Arizona Public Service's Evaluation

Subject: Request for Amendment to Technical Specifications

This letter is a request to amend Operating Licenses NPF-41, NPF-51, and NPF-74 for Palo Verde Nuclear Generating Station (PVNGS) Units 1, 2, and 3, respectively.

Figure 2-2
Proposed CPCS

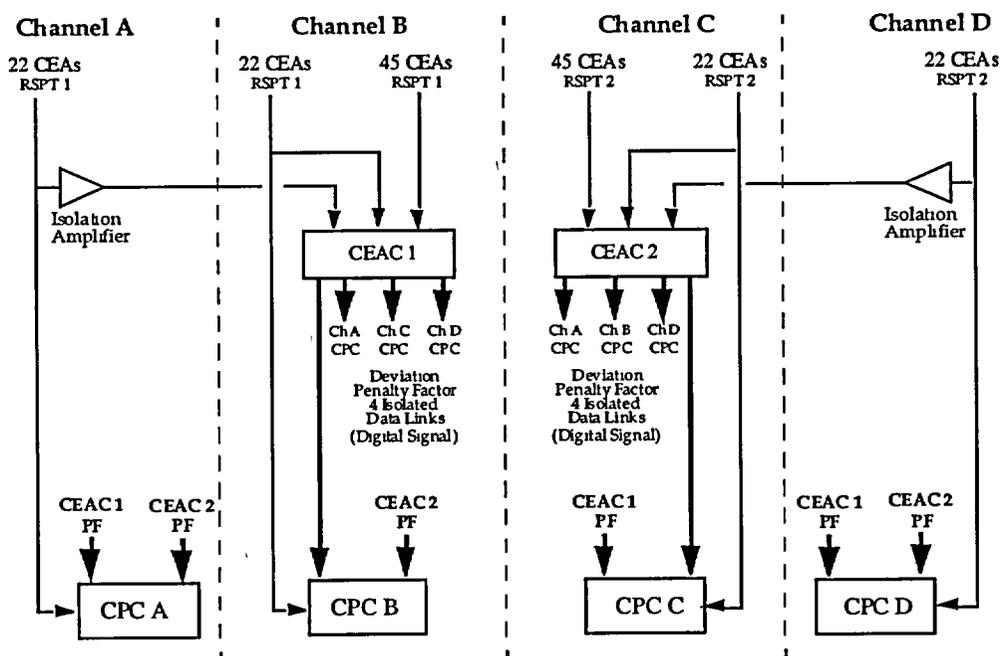
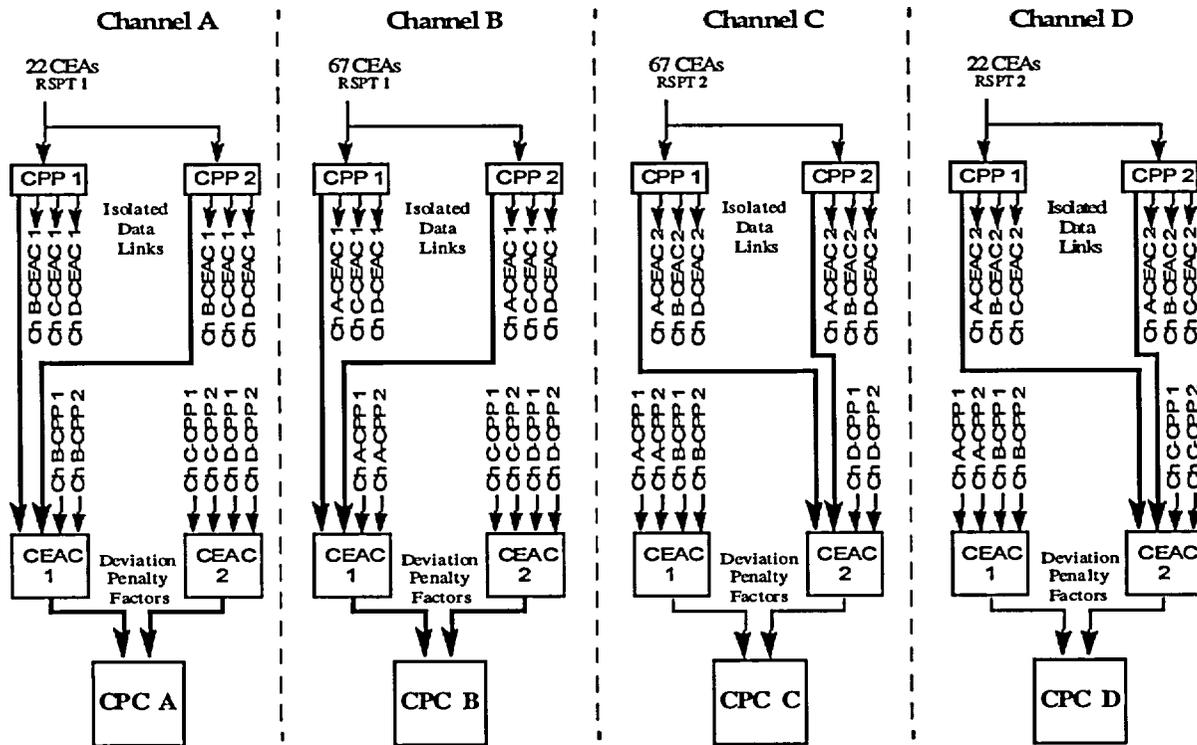
In the existing CPCS (Figure 2-1) there are only two Control Element Assembly Calculators (CEACs) physically mounted in channels B & C. There is only one CEAC 1 and one CEAC 2 in the entire four-channel CPCS. Each Control Element Assembly (CEA) position is measured by two redundant and independent Reed Switch Position Transmitters (RSPTs) associated with each CEA. Penalty factor outputs from each of these two CEAC channels are provided to all four Core Protection Calculator (CPC) channels via one-way isolated data links.

In the proposed replacement CPCS (Figure 2-2), there are eight CEACs, two in each CPC channel (i.e., a CEAC 1 and a CEAC 2 in each CPC channel), but the CEAC functionality remains the same. Each CEAC receives the same CEA inputs as in the present design. However, penalty factor outputs from the CEACs are used only in the associated CPC channel. In the replacement system, the CEA position inputs will undergo analog to digital conversion in the channel of origin, by means of redundant CEA position processors (CPPs 1 and 2) in each CPC channel. Converted CEA position is then transmitted to the associated CEAC 1 and CEAC 2 processors in each CPC channel.
